Bass Lake Outlet Berm Investigation

Township of Rideau Lakes
1439 County Road 8
Delta, Ontario
K0E 1G0

August 29, 2019

Figure 1-4. Recorded Bass Lake Water Elevation Data, provided by the Township (2010 - 2016)

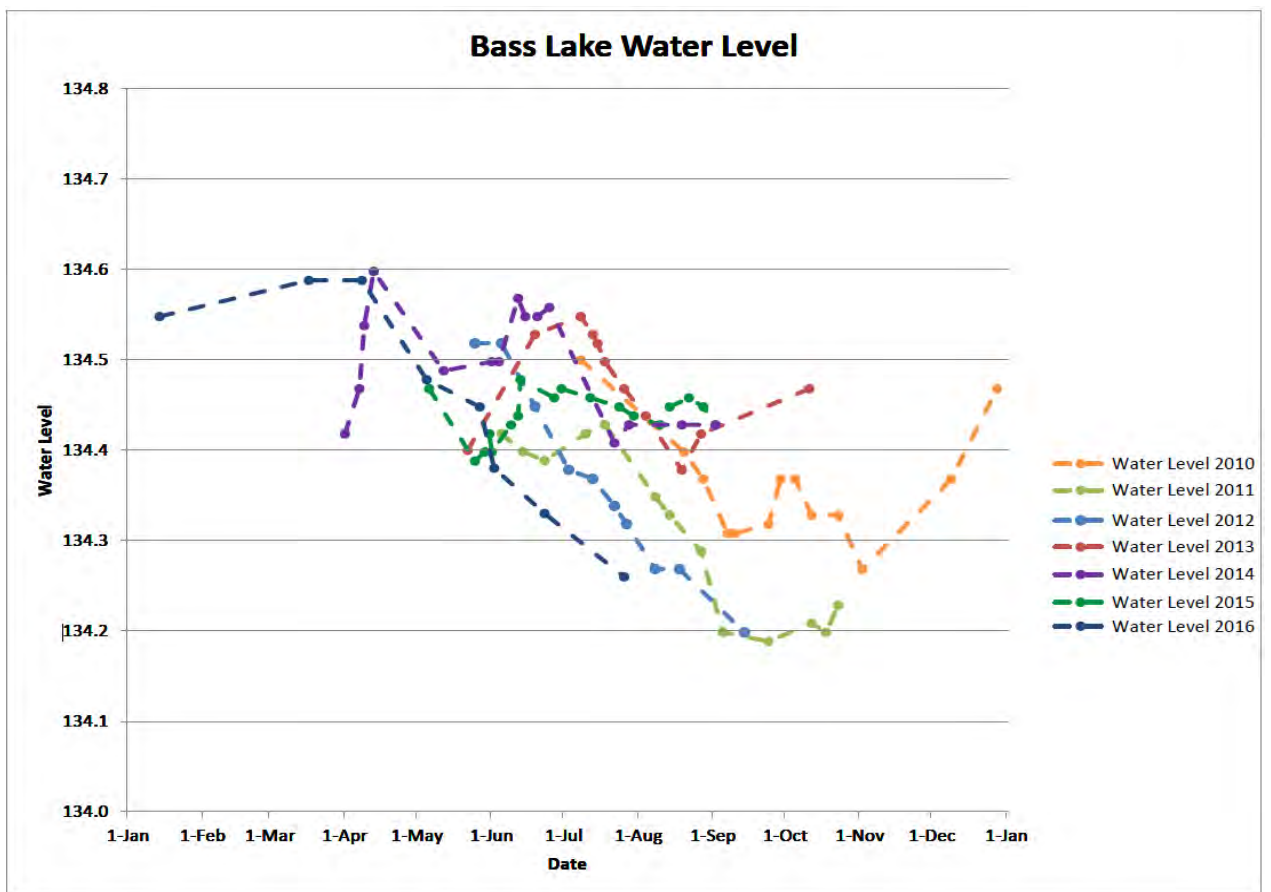
3. Clarify the traceability and reliability of the Chart depicting Water Level readings for period 2010-2016; (refer p.4)
4. Remove the repeated reference and declarations that a 1968 RVCA water level measurement of 133.8 MASL is anointed as the only historic datum point; (refer p.4)

Figure 1-3. Conclusions from the Water Elevation Data presented will be flawed since the sampling intervals and periods are essentially random. Without some method of normalization of the data presented it is spurious and not a realistic basis to make meaningful predictions.

The time and budget constraints involved in the project precluded a detailed data collection phase and the scope of Jp2g’s contract did not include topographic survey or establishment of water levels of record. Therefore, the data provided initially by the Township was taken at face value, despite Jp2g not being able to independently verify the data sets. Note that detailed design or formal establishment of an acceptable water level range would likely require additional topographic survey and/or water level measurements, as well as a consultation/acceptance of a satisfactory level through the RVCA. Similarly, the description of the berm’s history provided in the initial project documents was used as opposed to independent verification of the berm’s initial condition. The term “illegal” was not intended to reflect any criminal prosecution, rather just that the berm had been constructed without due process and in contravention of regulations. Additional background information and context has been added to the report.
